Memorandum

To: U.S. Environmental Protection Agency; National Remedy Review Board (NRRB)
From: Ann Maest, PhD; Buka Environmental on behalf of Bluewater Valley Downstream Alliance (BVDA)
Date: 10 March 2021
Re: NRRB Written Submittal for BVDA on the Homestake Mill Superfund Site

Figure 1. Uranium plumes in the alluvial aquifer in 2018.

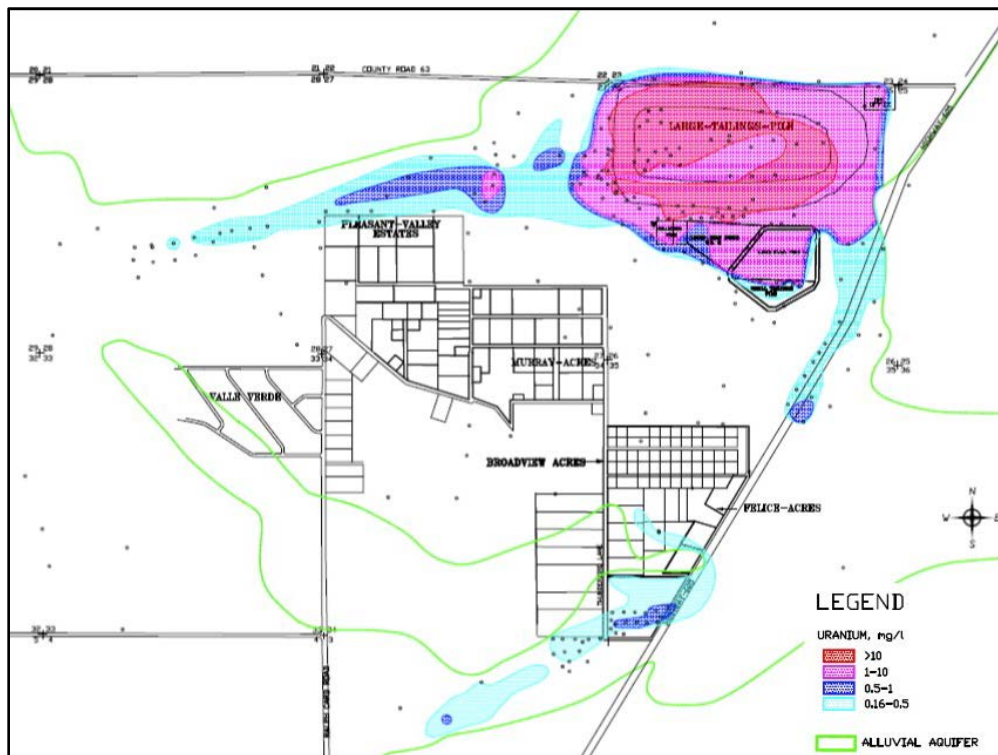
SAG water (GCAP, p. 4-5). Normally, hydraulic barriers to groundwater flow are created by pumping rather than injection, or by installing a slurry wall or other physical barrier to limit groundwater flow. The alluvial aquifer groundwater contours indicate that contaminated seepage from the LTP can still be transported to downgradient locations on the west and east sides of the LTP (2018 Annual Monitoring Report; Figure 4.2-1).³ A paleochannel in the alluvium on the west and southwest sides of the LTP has the highest measured hydraulic conductivity and is likely still transporting contaminants from the LTP to downgradient parts of the alluvial aquifer.⁴ The shape of the uranium plume indicates that the paleochannel is an important preferential pathway for transporting contaminants from the LTP to downgradient areas in the San Mateo Creek basin (Figure 1).

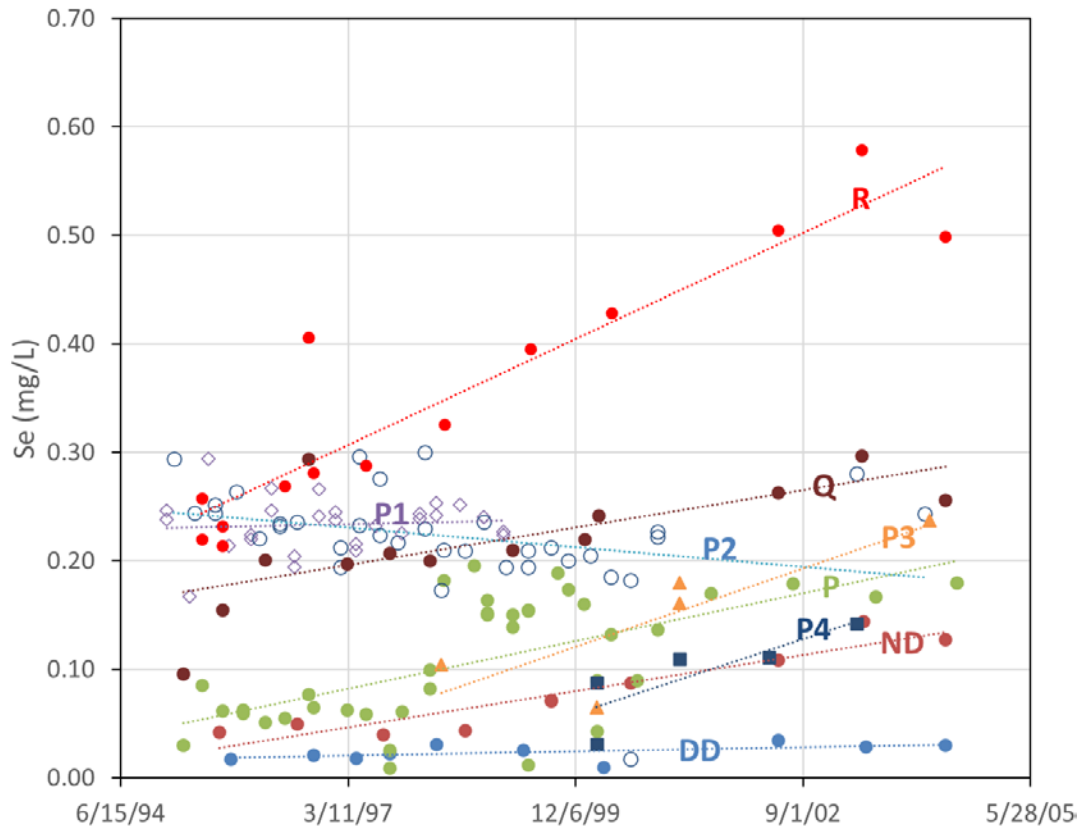
The current GWPS for the alluvial aquifer are based on values from 1995 to 2004 for the “near-upgradient” wells and include wells DD, ND, P, P1, P2, P3, P4, Q, and R (NRC, 2016; Arcadis, 2019). However, very few wells in the center of the alluvial aquifer were unaffected by mine-influenced water in the period from 1995 to 2004 (the period selected for the current GWPS), as shown in Figure 2. All alluvial wells except DD, P1, and P2 used in the current GWPS evaluation had increasing concentrations of selenium during this time period, indicating mine-related influence, likely from upgradient mines in the San Mateo Creek basin.

The proposed GWPS excludes wells Q and R and uses wells P (1995-1997), DD (1981-2014), ND (1983-1998), and 916 (1994-2005). Selenium concentrations in wells P1 and P2 have consistent concentrations over the narrow period of sampling (see Figure 2), but concentrations are similar to those in R and Q, which are known to be affected by mining-related sources. While wells R and Q had lower concentrations before the early 1990s, wells P1 and P2 were not sampled during this timeframe. P3 concentrations increased from the first sampling, so this well was excluded from consideration as background. Well P concentrations jumped in 1998, and concentrations from 1998 forward are not used.
